From: Bentley, Donald E <DBENTLE@entergy.com>
Sent: Thursday, November 30, 2017 6:10 PM
To: Sebrosky, Joseph
Subject: [External_Sender] Palisades Nuclear Plant FHRR Staff Assessment Input
Attachments: Attachment A Figure 14-WaterElev-Powerblock.pdf; Attachment A Figure 13-FlowDepth-Powerblock.pdf; Attachment A Figure 5-Critical Locations Figure (3).pdf

Palisades Nuclear Plant Flood Hazard Reevaluation Report (FHRR) Audit Report ML16174A248 Information Need 2 in Table 1 addressed FHRR Figure 3-1 and Figures 5, 13, and 14 in Calculation No. 32-9226944-002 "Palisades Nuclear Plant Flooding Hazard Re-evaluation – Local Intense Precipitation". During the audit, modified Figures 5, 13, and 14 from Calculation No. 32-9226944-002 were made available to the staff for review.

Figure 14: Maximum Water Surface Elevation (feet, NGVD29) within Power Block Area

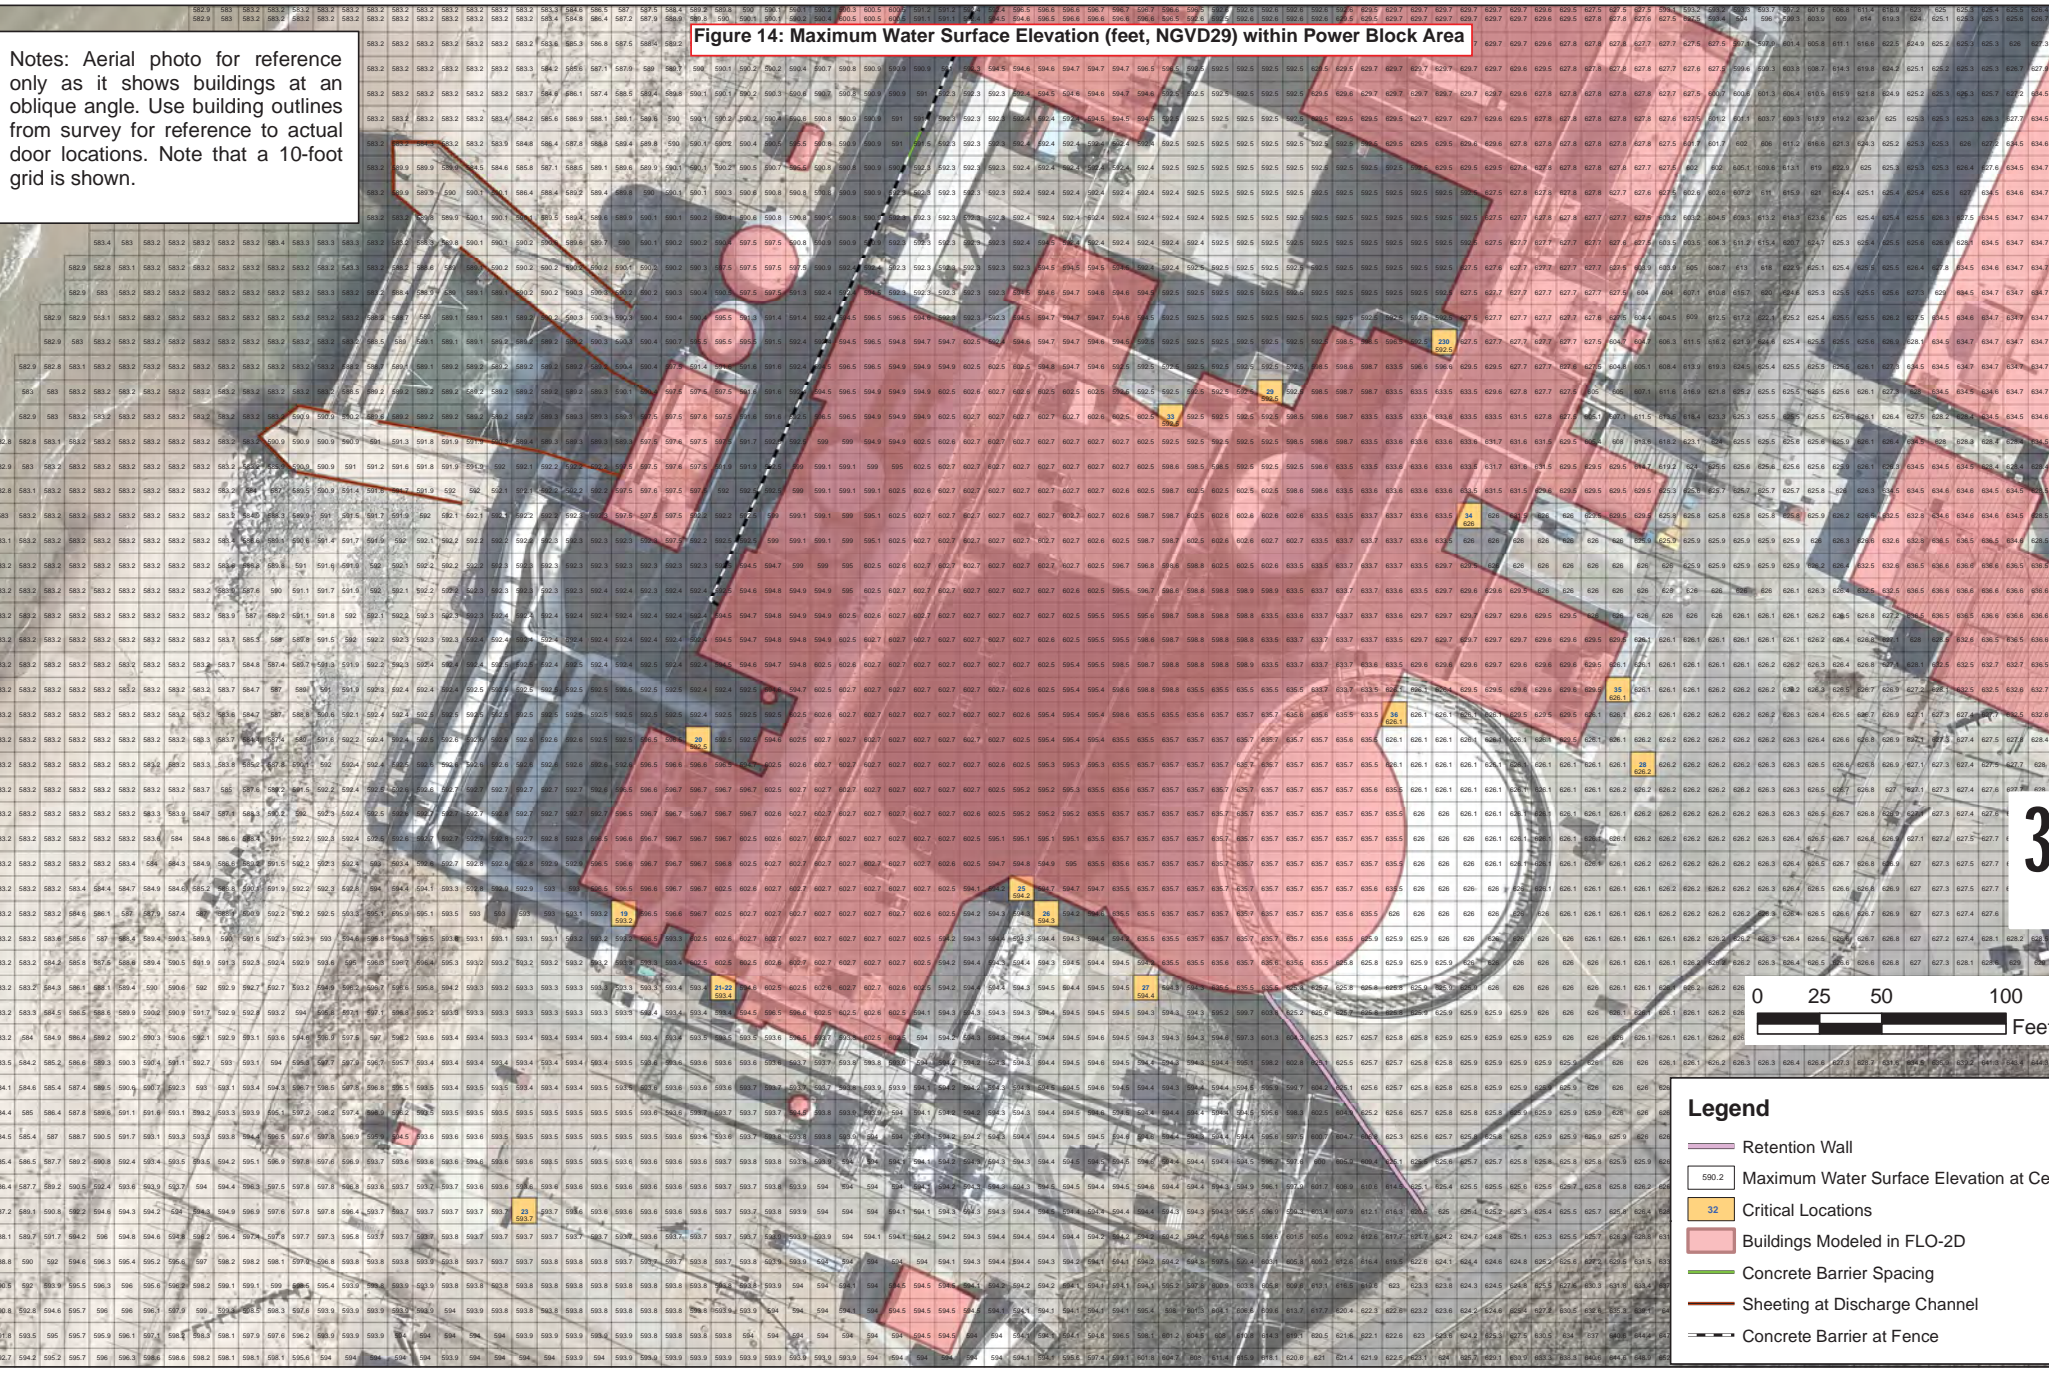
Post Audit Action for Information Need 2 stated that the licensee modified figures provided that shows all the structures listed in Table 3-1 with their names, and representative grid elements for critical locations and their identification numbers, and requested that these figures be submitted on the docket.

As requested, attached to this email are the figures made available during the Audit:

Attachment A Figure 14-WaterElev-Powerblock
